# CHANGES FROM RELEASE 2023-02 TO 2023-03 FOR EOS C VTOL UAV

357-204-101436-01-10

2023-12-20

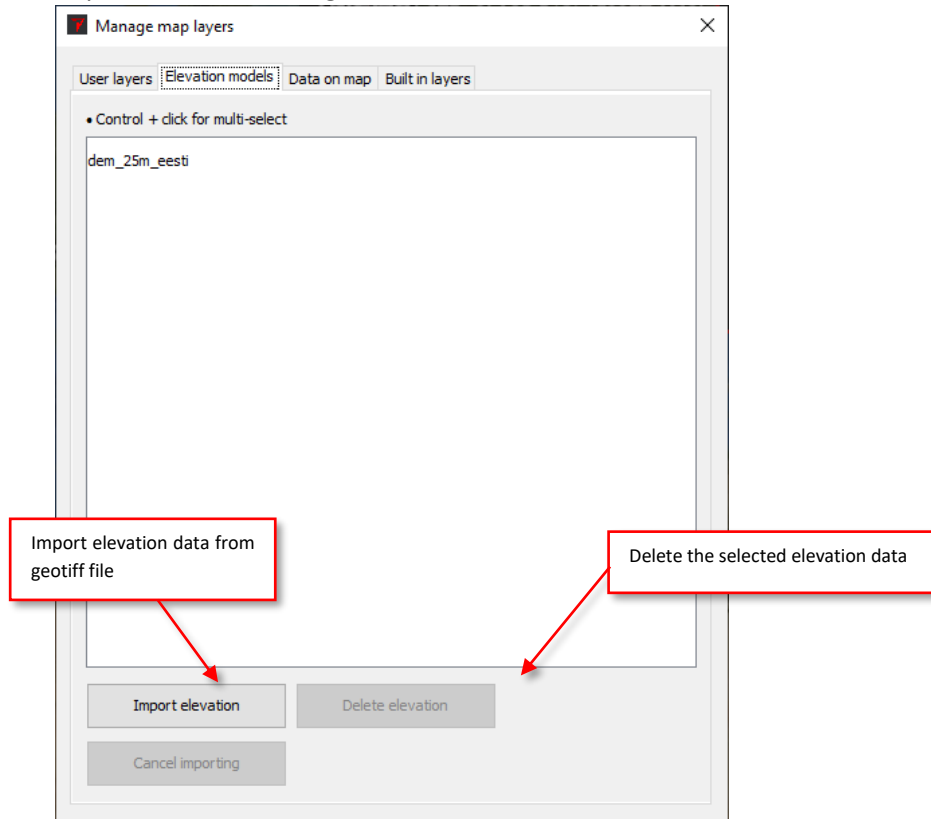
- Added gimbal Power Cycle button to payload tab in gimbal settings window. Power Cycle button restarts the whole gimbal. **NB!** Gimbal must support it (newer gimbals have the functionality and hardware to do it).
